Title - Sujet Food Service Bldg Westmorland Inst	
Solicitation No. - N° de l'invitation EC016-141832/A	Amendment No. - N° modif. 004
Client Reference No. - N° de référence du client EC016-141832	Date 2014-01-17
GETS Reference No. - N° de référence de SEAG PW-\$PWB-020-3350	
File No. - N° de dossier PWB-3-36100 (020)	CCC No./N° CCC - FMS No./N° VME
Solicitation Closes - L'invitation prend fin at - à 02:00 PM on - le 2014-01-23	Time Zone Fuseau horaire Atlantic Standard Time AST
F.O.B. - F.A.B. Plant-Usine: <input type="checkbox"/> Destination: <input type="checkbox"/> Other-Autre: <input type="checkbox"/>	
Address Enquiries to: - Adresser toutes questions à: Donovan, Janine PWB	Buyer Id - Id de l'acheteur pwb020
Telephone No. - N° de téléphone (506) 636-5347 ()	FAX No. - N° de FAX (506) 636-4376
Destination - of Goods, Services, and Construction: Destination - des biens, services et construction:

This Tender Amendment No. Four (4) is raised to include the following Addendum No. Four (4).

Addendum No. 4

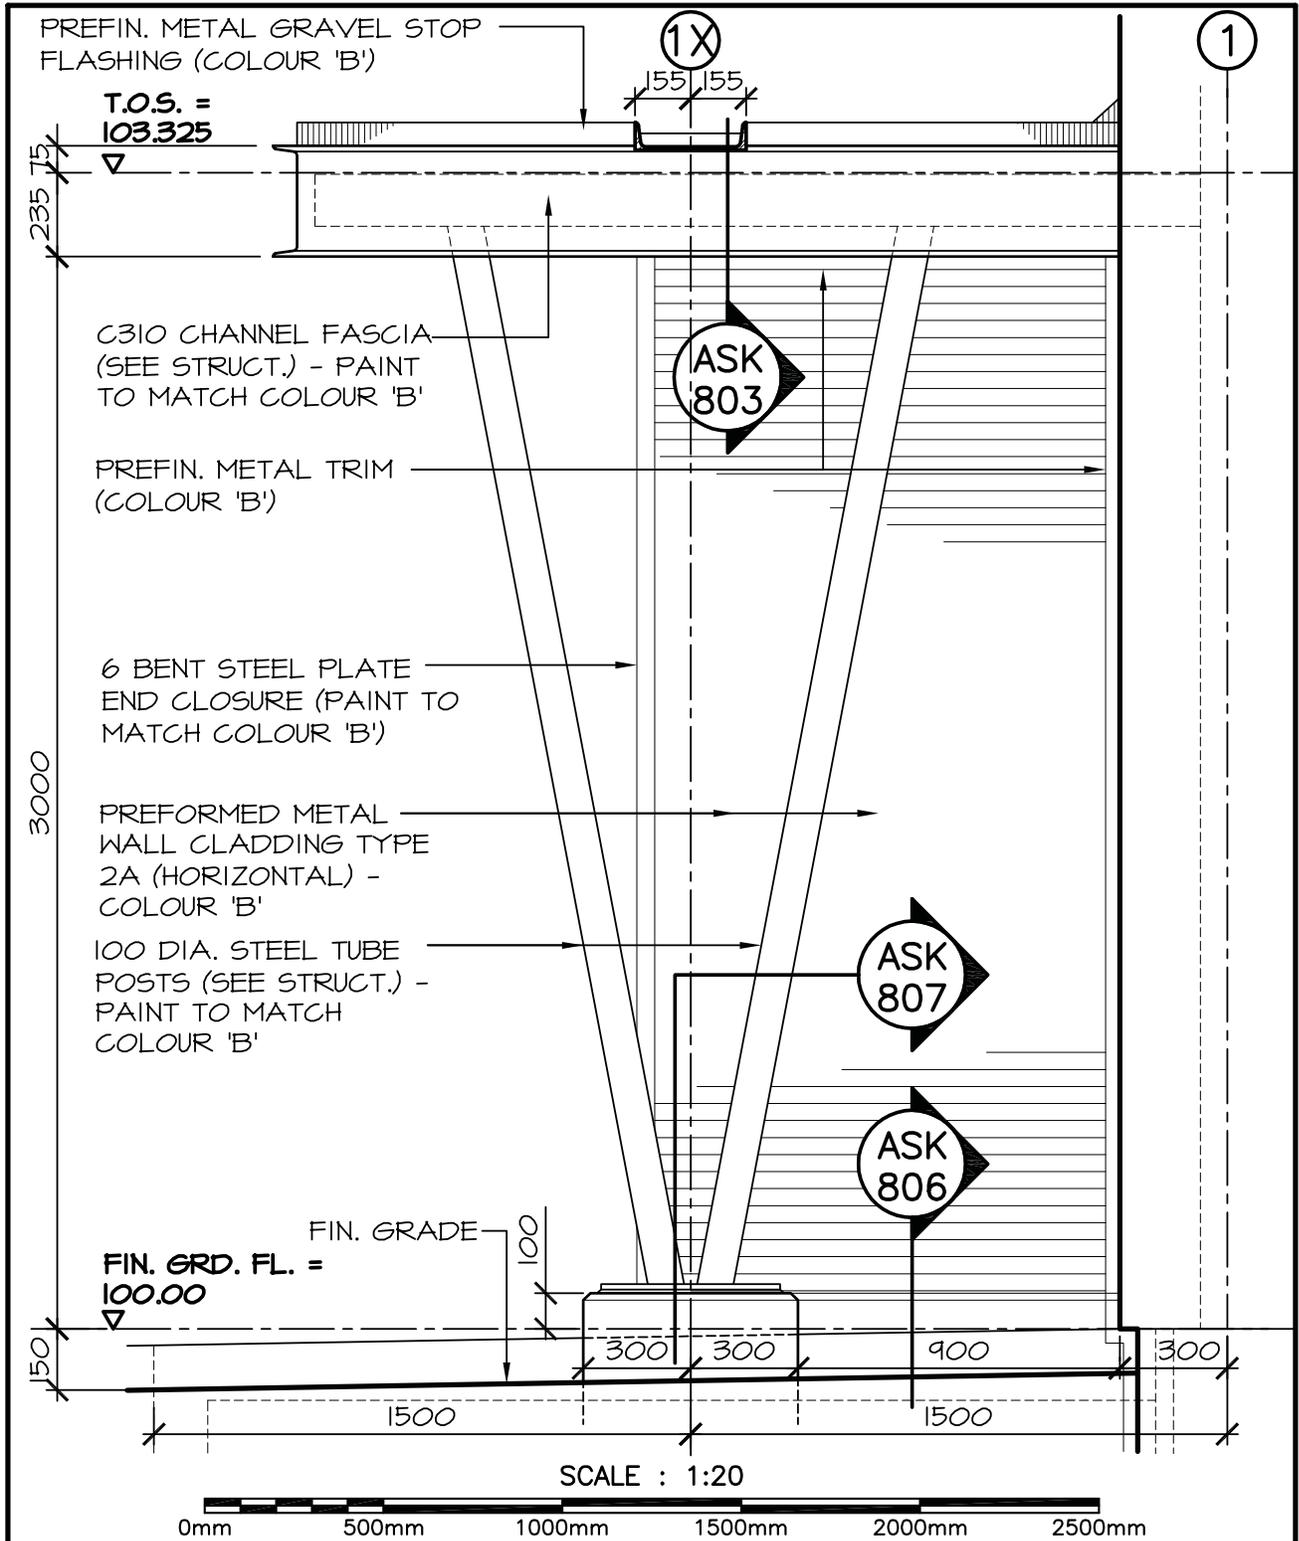
13. In reference to detail drawing 1/A8.3, please provide details for the wind break/screen at the canopy.

Answer: *This feature is detailed as part of the entrance canopy, details of which are included with this Addendum.*

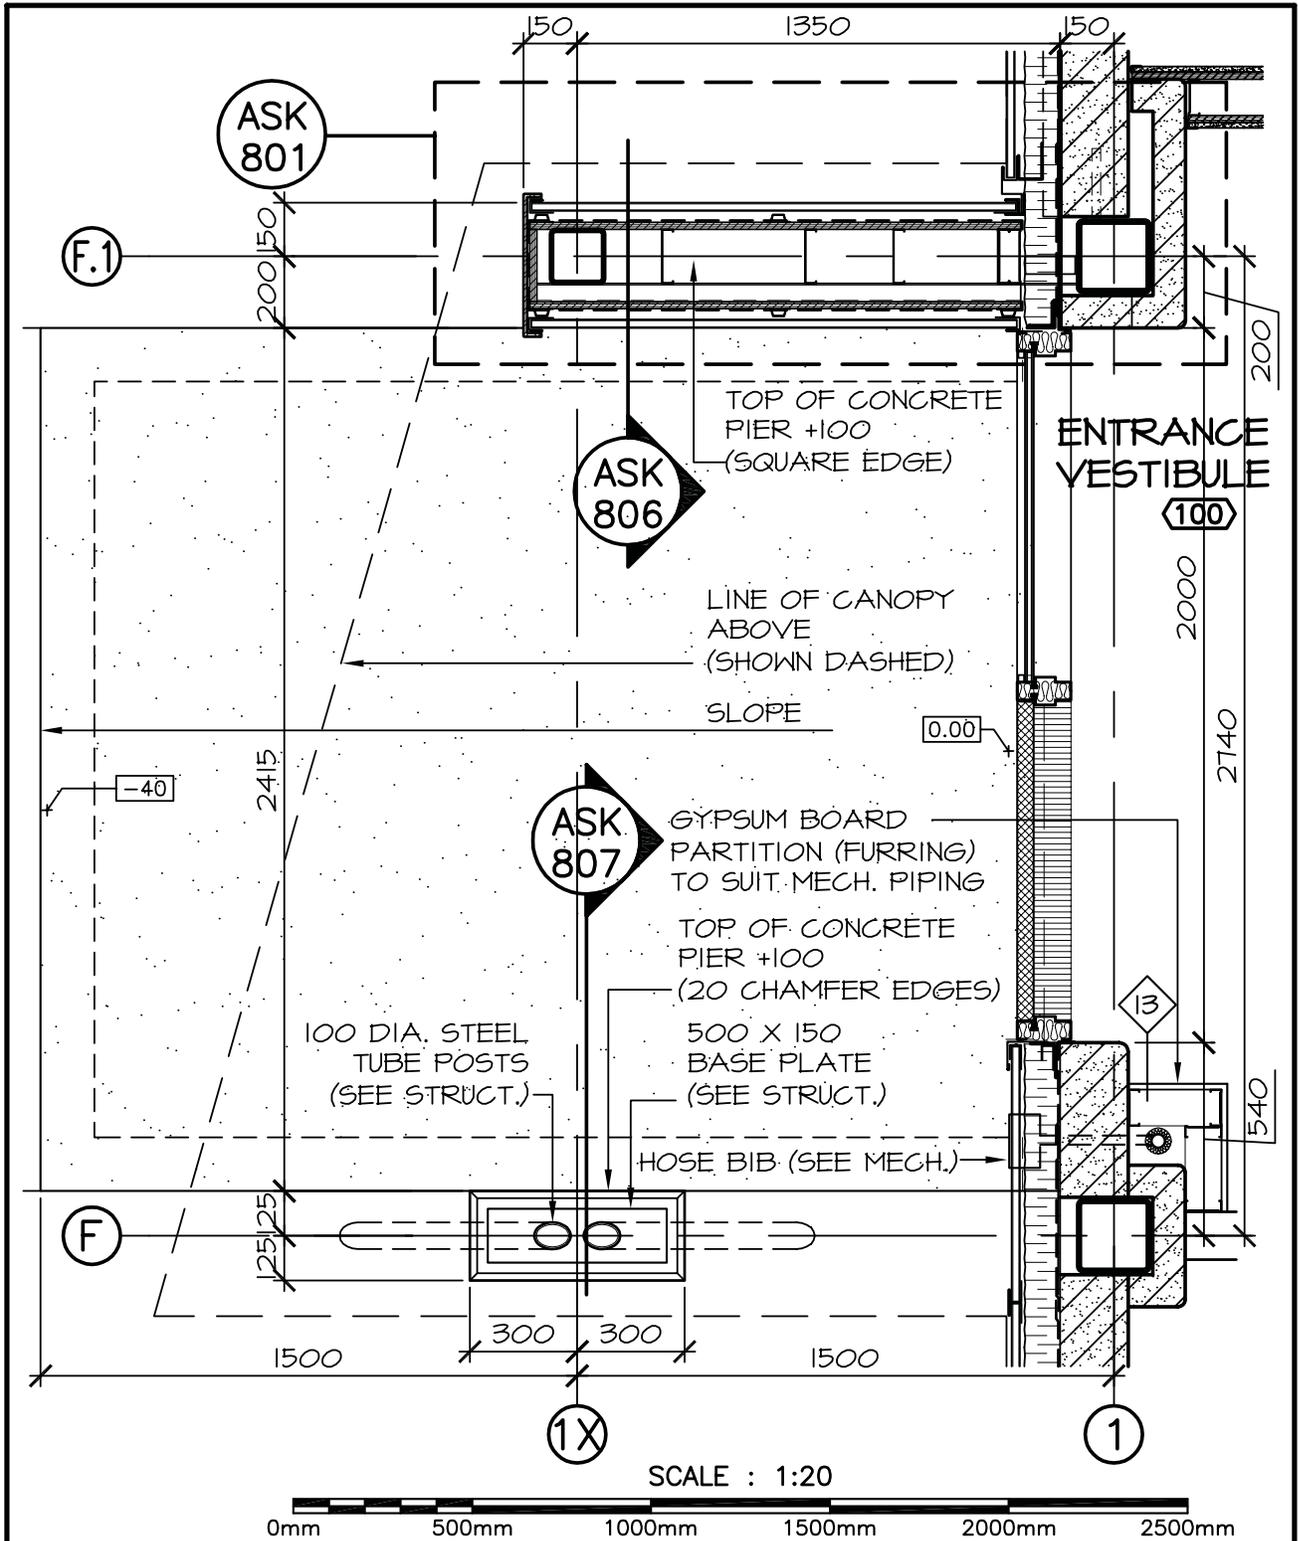
2. On drawing A2.2 there appears to be a railing on each side of the main entrance ramp. Are these railings to be included, and if yes, please provide details and dimensions.

Answer: *Yes, railings are shown on the drawing and they are required on both sides of the exterior ramp and exterior stairs at the main entrance. Details are included with this Addendum.*
